Final Environmental Impact Statement
(Final Supplement to FEA FES 76/77-6)

**STRATEGIC PETROLEUM
RESERVE**

Bryan Mound Salt Dome
Brazoria County, Texas

DECEMBER 1977

Figure 1 BRYAN MOUND REVISED FRESHWATER INTAKE AND BRINE DISPOSAL SYSTEMS LOCATIONS

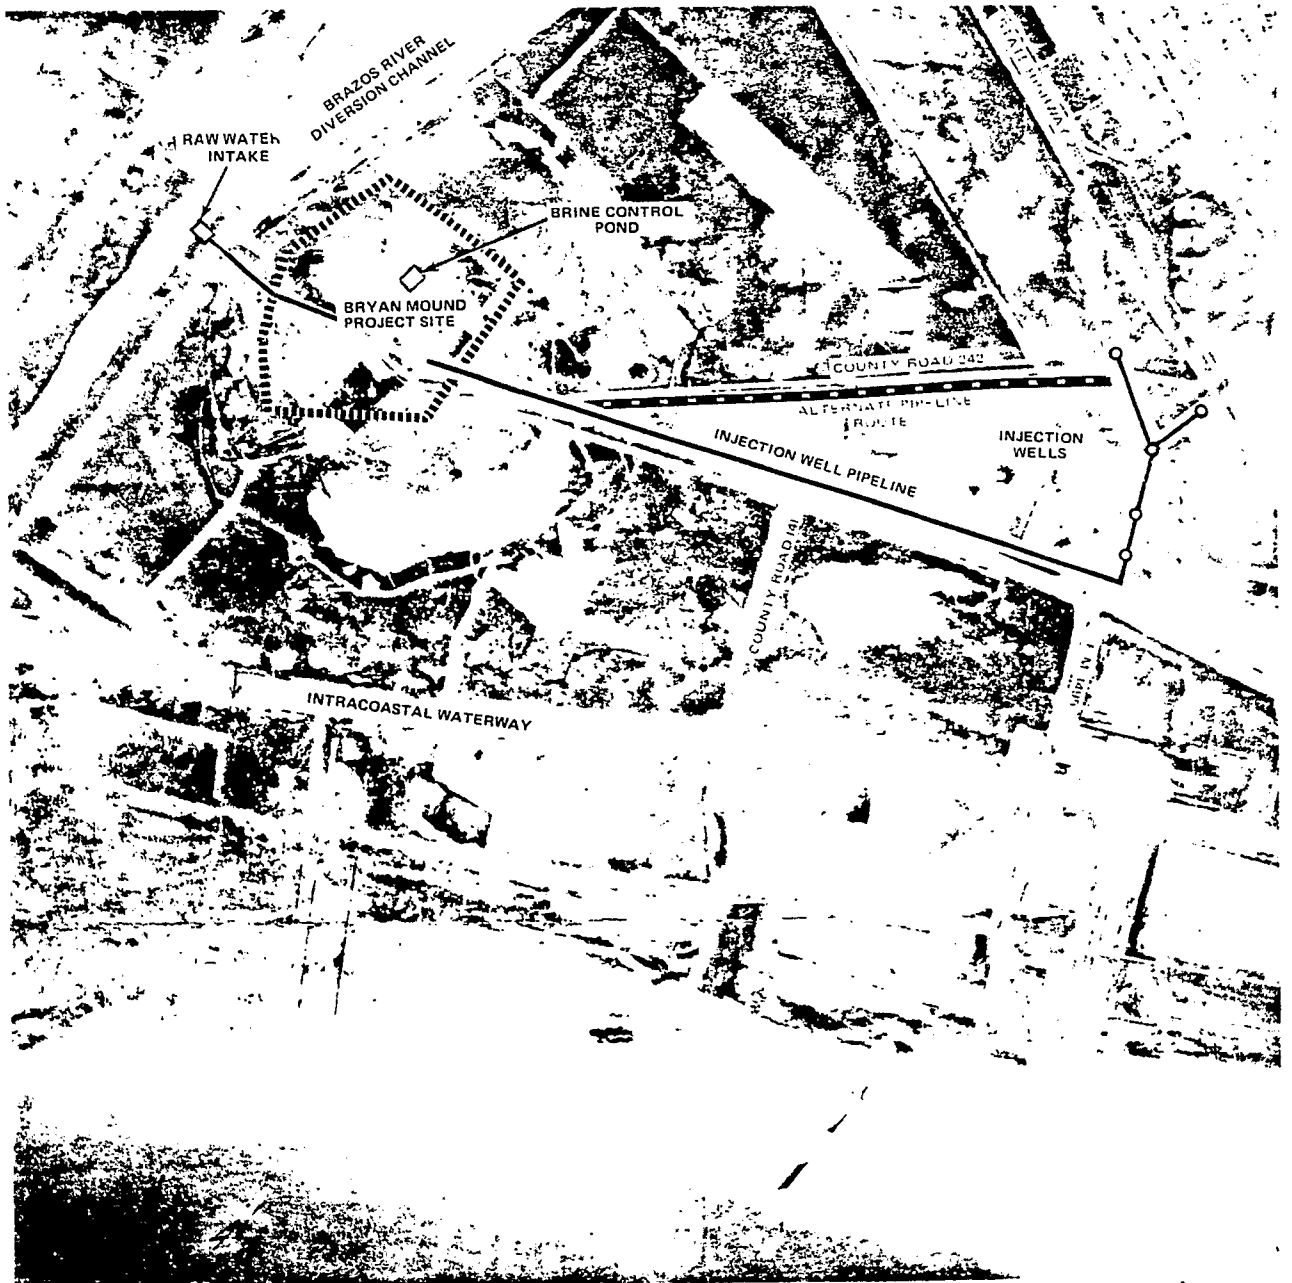
After consultation with the U.S. Fish and Wildlife Service, National Marine Fisheries Service, Texas Parks and Wildlife Department, and the U.S. Corps of Engineers the proposed well locations as denoted in the draft statement, figure 1, page 1-4, have been moved from west of route 1495 to the east side as illustrated in figure 1. This eastward relocation will place the well pads in an area which has a lower marsh habitat value and has been designated as a Corps of Engineers spoil disposal area for the Freeport Harbor project.

Figure 2 CONCEPTUAL WATER INTAKE STRUCTURE AT BRYAN MOUND (Cont'd.)

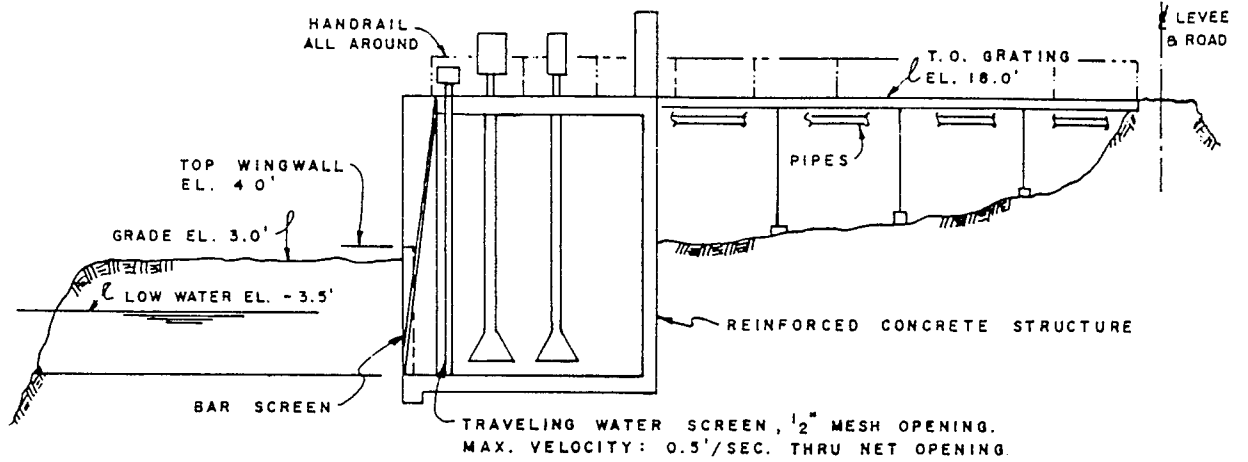
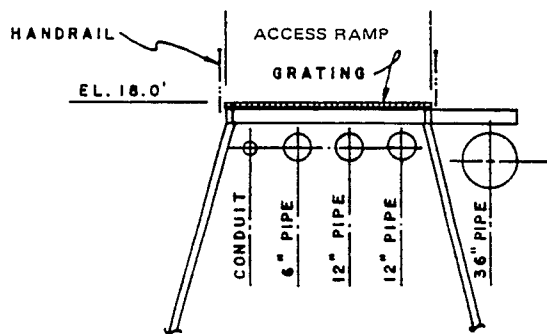
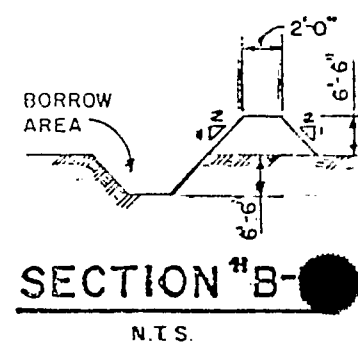
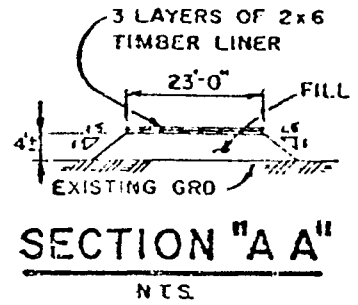
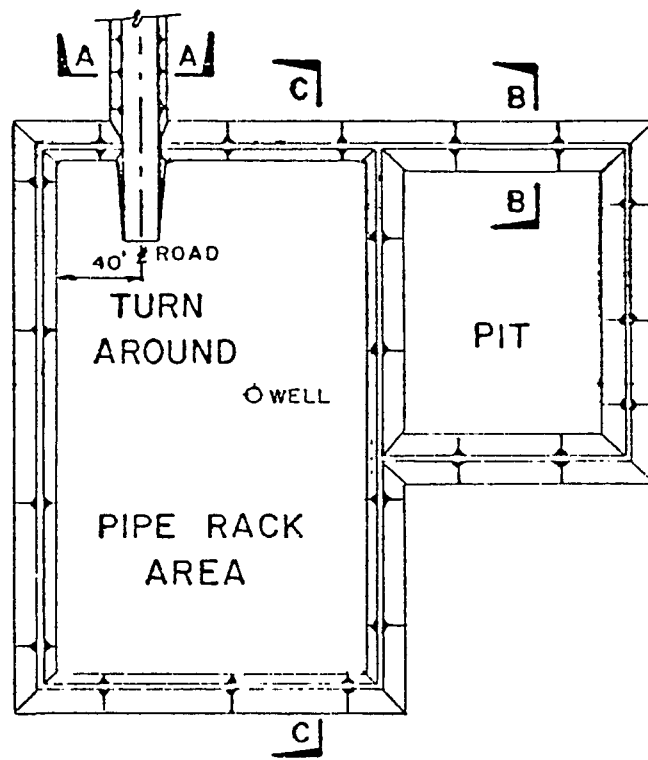
g. Pumps and mechanical gear susceptible to flood damage should be raised to an elevation at or above the one percent flood elevation in consonance with Executive Order 11988. "Normal flooding elevations" is an ambiguous term which does not specifically indicate compliance with the flood damage prevention requirements contained in the Executive Order. Figure 2 implies that susceptible gear is located above 18 feet elevation, but such items are not specifically labelled on the elevation view.

Figure 1 BRYAN MOUND REVISED FRESHWATER INTAKE AND BRINE DISPOSAL SYSTEMS LOCATIONS

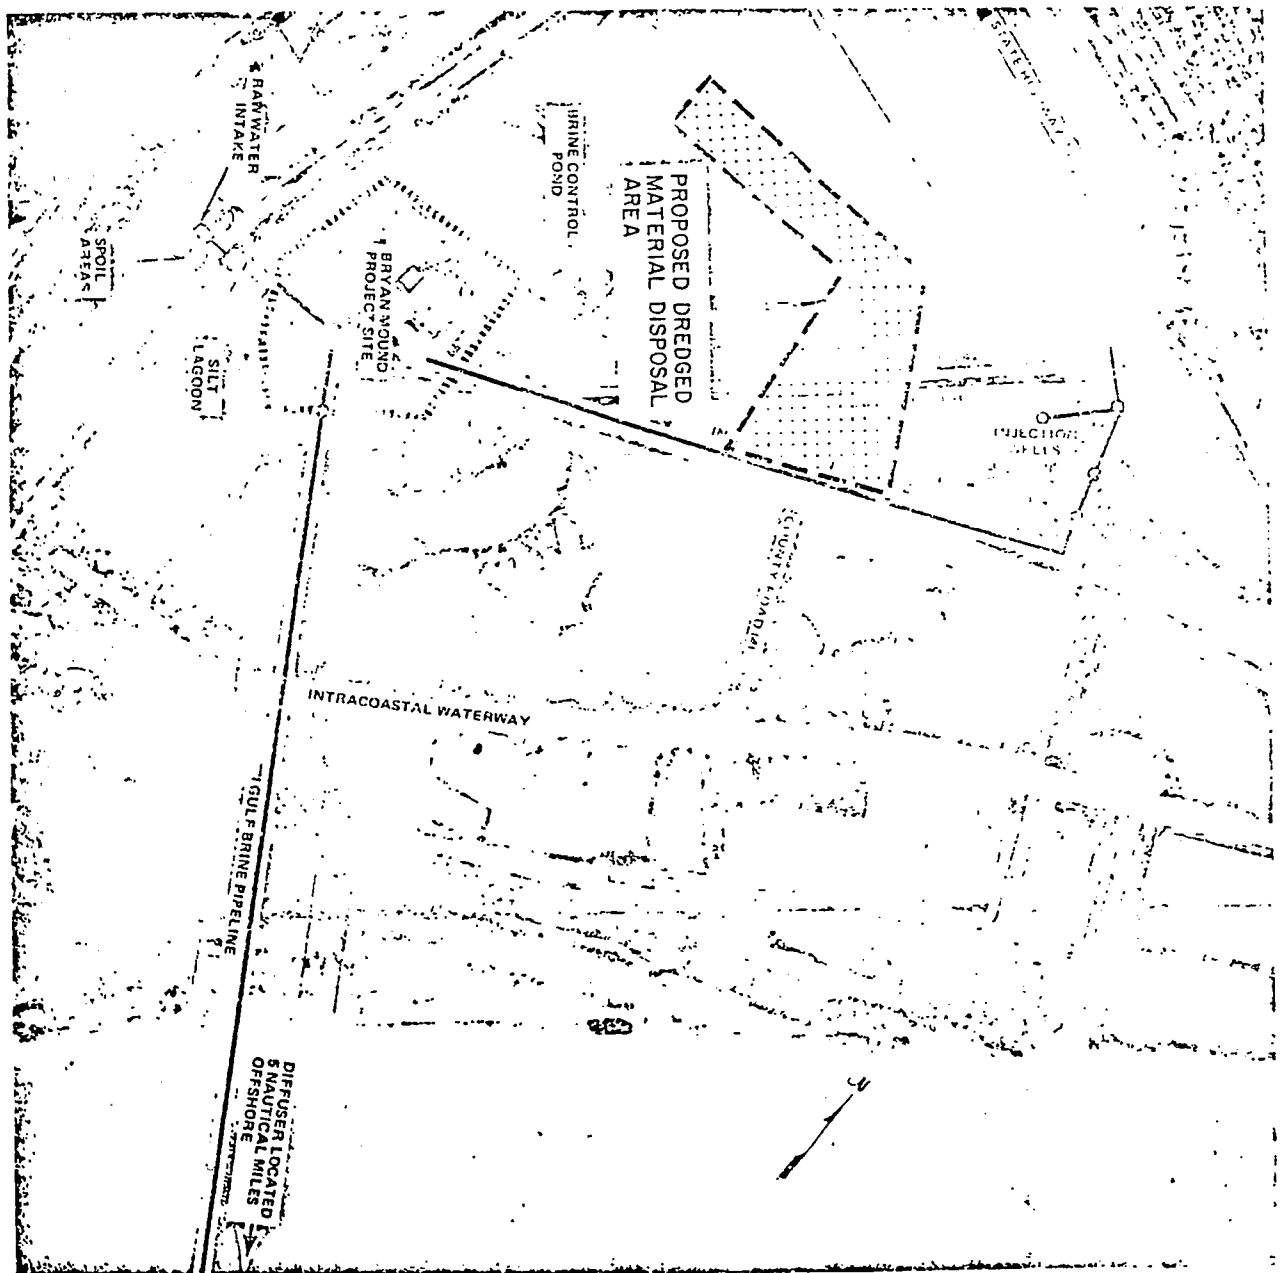
a. The authorized 45-foot Federal Navigation Channel Enlargement for Freeport Harbor would have a proposed dredged material disposal area near the injection well pipelines. A copy of Figure 1, page 4, showing the proposed dredged material disposal site is inclosed.
